OFR-03-08

**Review of Geologic Report
for Surfrider Resort Proposal,
Lincoln County, Oregon
OPRD Permit #BA-555-03**

**REVIEW OF GEOLOGIC REPORT FOR SURFRIDER RESORT PROPOSAL,
LINCOLN COUNTY, OREGON
OPRD PERMIT #BA-555-03**

April 11, 2003

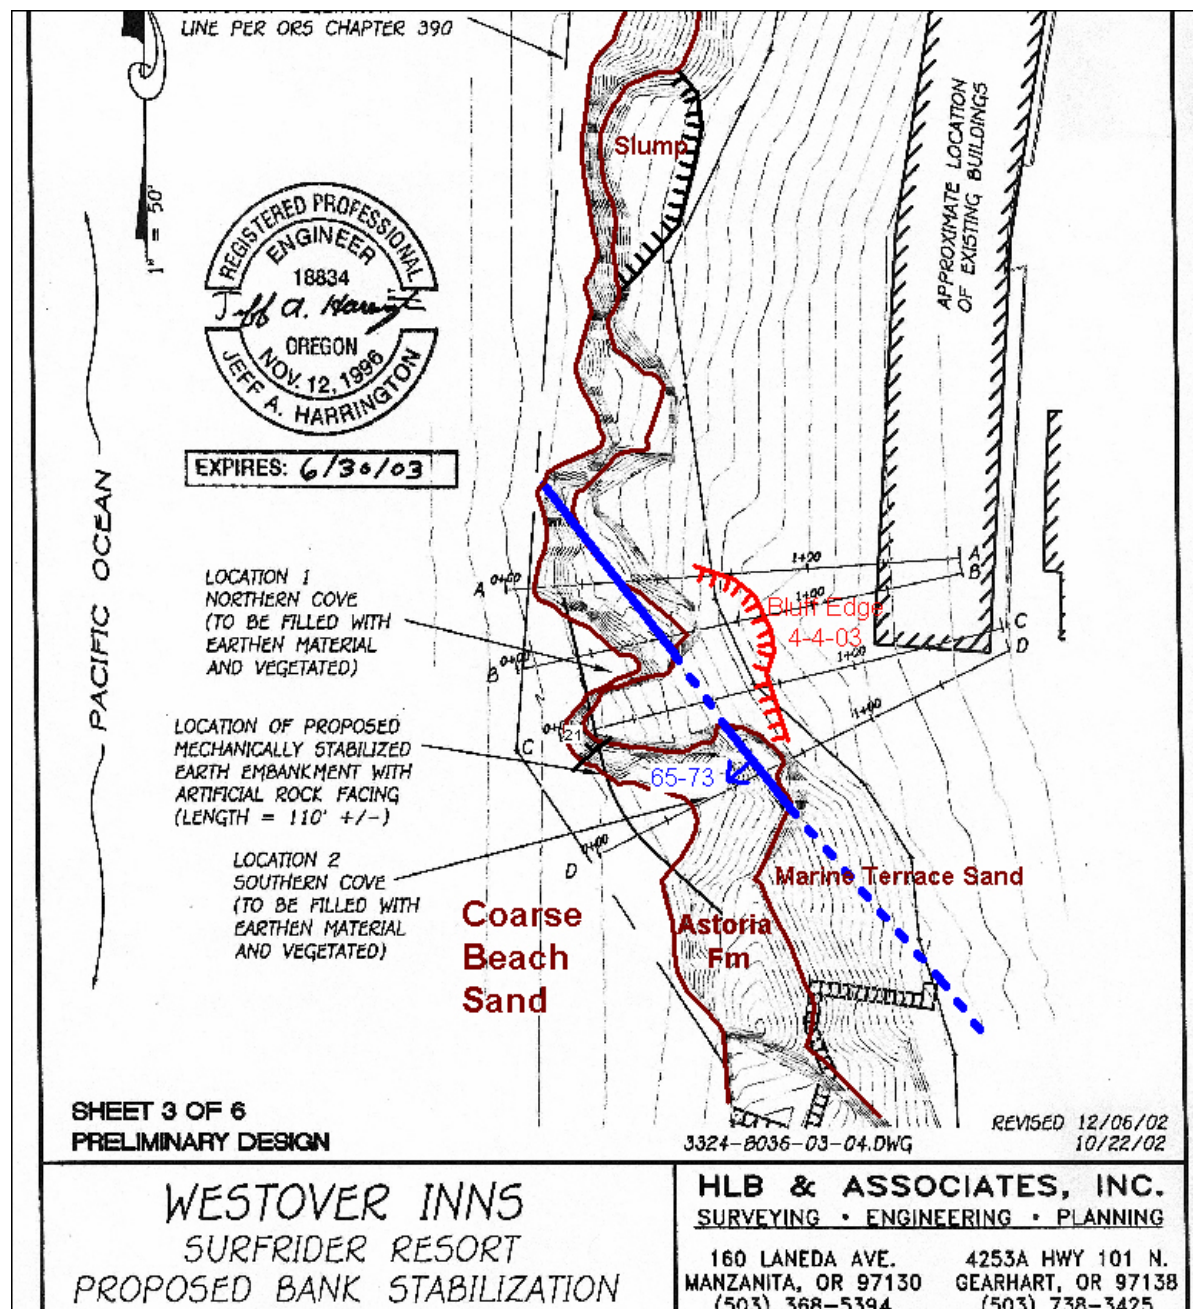
Regarding erosion around the sides of the SPS, the report does not address likely erosion along the extension of the N35°W shear zone immediately north of the proposed north end of the SPS. This zone of weakness could provide early breaching to the side of the SPS, which may lead to destabilization of the structure.

The report does not address the apparent slump feature noted in the north part of the study area north of the proposed SPS (Figure 3). Propagation of further slope failures of this kind may threaten the northern part of the resort in the future. If this is a translational failure, it may have implications for translational failures that could affect the SPS.
